Enclosure 2
Meeting Summary Handouts
of the August 15, 2011
ROP Public Meeting
Dated July 13, 2011

REACTOR OVERSIGHT PROCESS (ROP) MONTHLY PUBLIC MEETING AGENDA

July 13, 2011; 9:00 AM – 2:30 PM; Two White Flint North Building;
Conference Room – T-10A1

Figure F-6

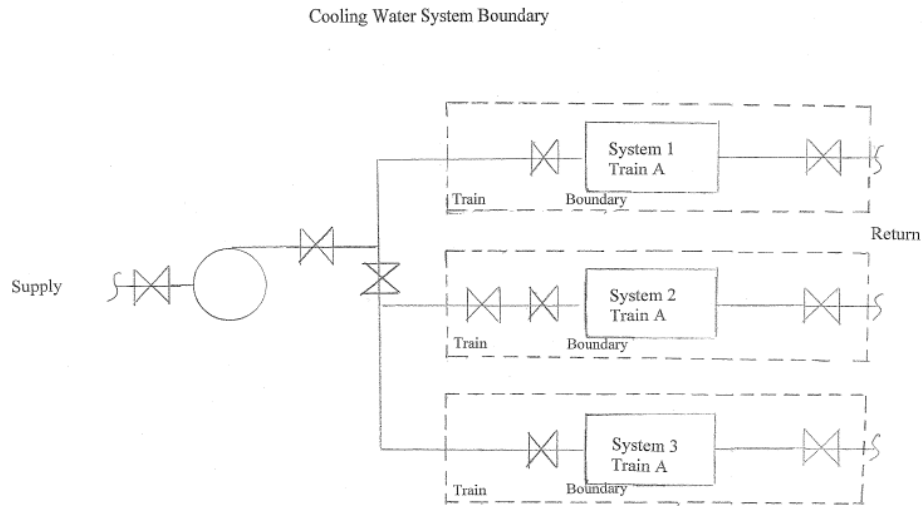
Question - Should a cooling water system isolation valve(s) in a line supplying a single monitored component be included in the monitored train's system boundary?

Comment [A6]: Because the figure doesn't specify the SSCs by name or system type, text was proposed in an attempt to make it more obvious.

Response – Yes, a cooling water system isolation valve(s) in a line supplying a single monitored train should be included in the monitored train's system boundary.

Pumps, valves, heat exchangers and line segments that are necessary to provide cooling to ~~the other~~ monitored ~~systems~~ trains or segments of system(s) supported by the cooling water system are included within the cooling water system ~~scope~~ boundary up to, but not including, the ~~last~~ isolation valve(s) that connects the cooling water ~~support~~ system to components in a single monitored ~~system~~ train or segment of the supported system. This ~~last~~ isolation valve is included within the ~~other~~ boundary of the monitored ~~system~~ train or segment of the supported system boundary. ~~If the~~ The last valve(s) that provides cooling to SSCs in more than one monitored ~~system or train~~ train or segment of supported system(s), ~~then it~~ is included within the boundary of the cooling water ~~support~~ system. All valves (e.g., manual isolation valves or motor operated valves) in a cooling water line to a single monitored train or segment of a supported system are included within the boundary of the monitored train or segment of the supported system. Figure F-6 depicts this concept and the treatment of multiple isolation valves. The SSCs outside the dashed boxes are included within the boundary of the cooling water system. The SSCs within the dashed boxes are included within the boundaries of the supported systems. ~~Service water systems are typically open "raw water" systems that use natural sources of water such as rivers, lakes or oceans. Component Cooling Water systems are typically closed "clean water" systems.~~

Page F-55, Figure F-1

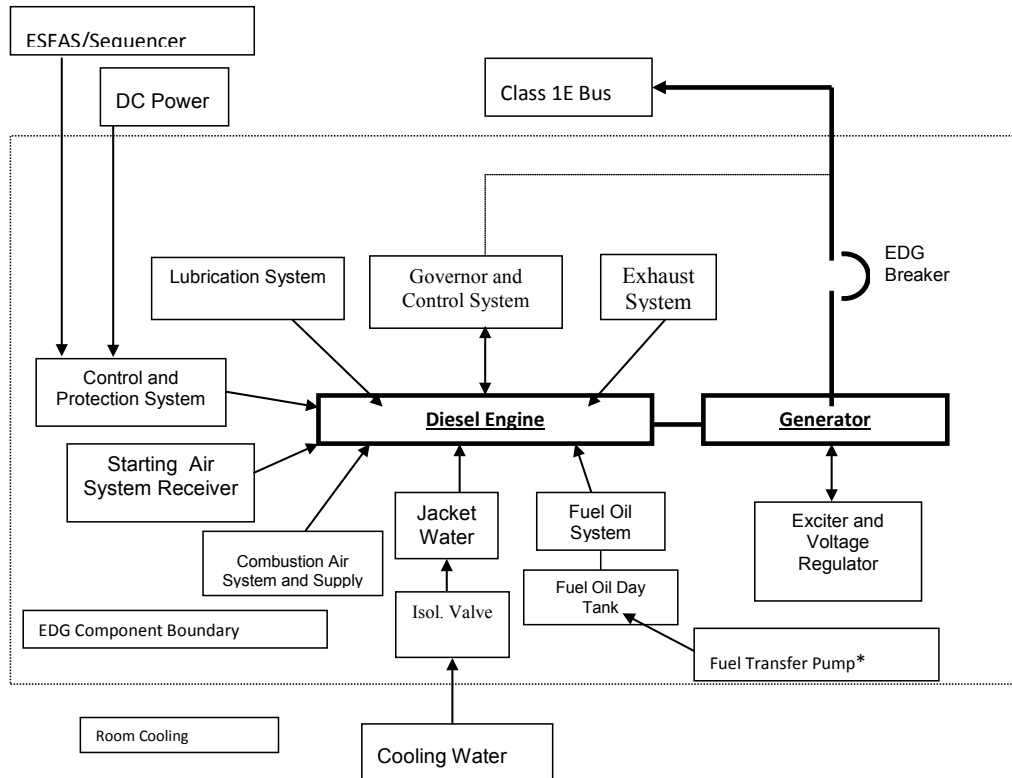
NEI 99-02 section F.5 page F-45 provides inconsistent treatment of EDG Fuel Oil Transfer pumps (FOTPs). The FOTPs are identified as being within the system boundary but are not monitored components nor do they contribute to the unavailability unless there is only one pump per EDG. As noted in the guidance, the reason for this treatment is that the FOTP contribution to MSPI was expected to be small. Additional investigation has shown that for some plant configurations, the contribution from the FOTPs could be significant, based on plant design details such as number of pumps, number of EDGs, Day Tank Capacity, cross connect capability, etc. Therefore, appropriate consideration of the FOTPs in MSPI is needed.

Revise NEI 99-02 section F.5 and Figure F-1 to include the Fuel Oil Transfer Pumps within the EDG super-component boundary.

The fuel transfer pumps required to meet the PRA mission time are within the **EDG component system** boundary, but are not considered to be a **separate** monitored component for reliability monitoring in the EDG system. Additionally they are monitored for contribution to train unavailability **only if the fuel oil transfer pump(s) is (are) required to meet the EDG mission time (as specified in the first paragraph of Section F.2.2.2 and as defined in the MSPI Definition of Terms section)**, an EDG train can only be supplied from a single transfer pump. Where the capability exists to supply an EDG from redundant transfer pumps, the contribution to the EDG MSPI from these components is expected to be small compared to the contribution from the EDG itself. Monitoring the transfer pumps for reliability is not practical because accurate estimations of demands and run hours are not feasible (due to the auto start and stop feature of the pump) considering the expected small contribution to the index.

Page F-55, Figure F-1

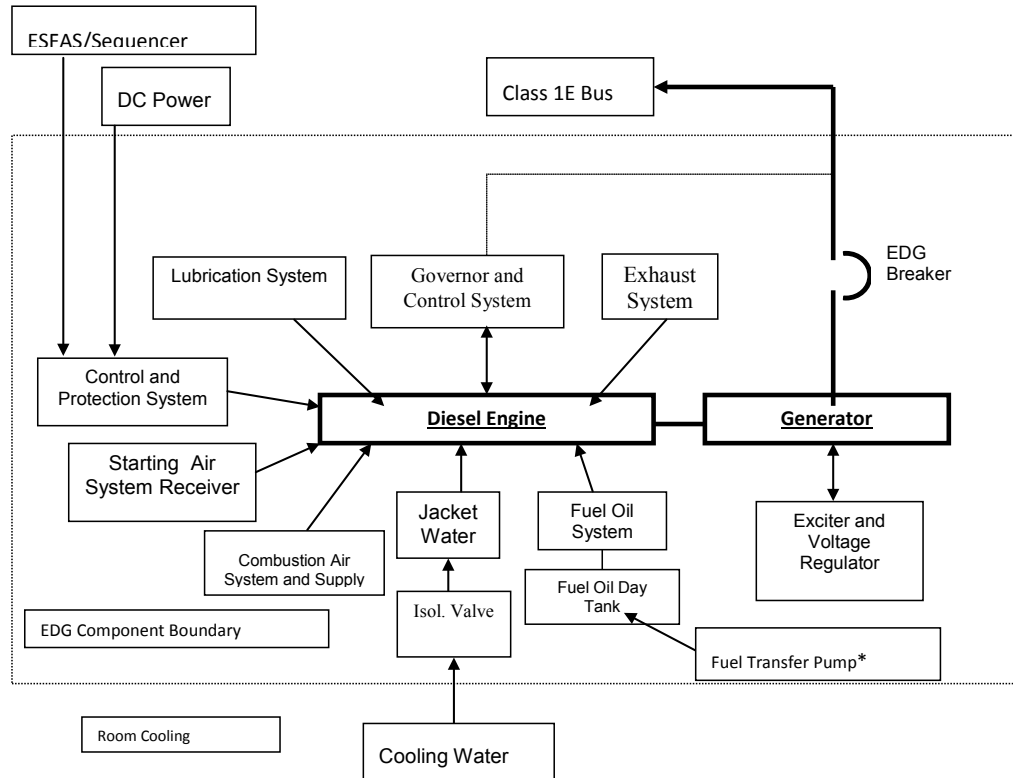
Revise NEI 99-02 section F.5 and Figure F-1 to include the Fuel Oil Transfer Pumps within the EDG super-component boundary.

The fuel transfer pumps required to meet the PRA mission time are within the **EDG component system** boundary, but are not considered to be a **separate** monitored component for reliability monitoring in the EDG system. Additionally they are monitored for contribution to train unavailability ~~only~~ if **the fuel oil transfer pump(s) is (are) required to meet the EDG mission time (as specified in the first paragraph of Section F.2.2.2 and as defined in the MSPI Definition of Terms section)**, an EDG train can only be supplied from a single transfer pump. Where the capability exists to supply an EDG from redundant transfer pumps, the contribution to the EDG MSPI from these components is expected to be small compared to the contribution from the EDG itself. Monitoring the transfer pumps for reliability is not practical because accurate estimations of demands and run hours are not feasible (due to the auto start and stop feature of the pump) considering the expected small contribution to the index.
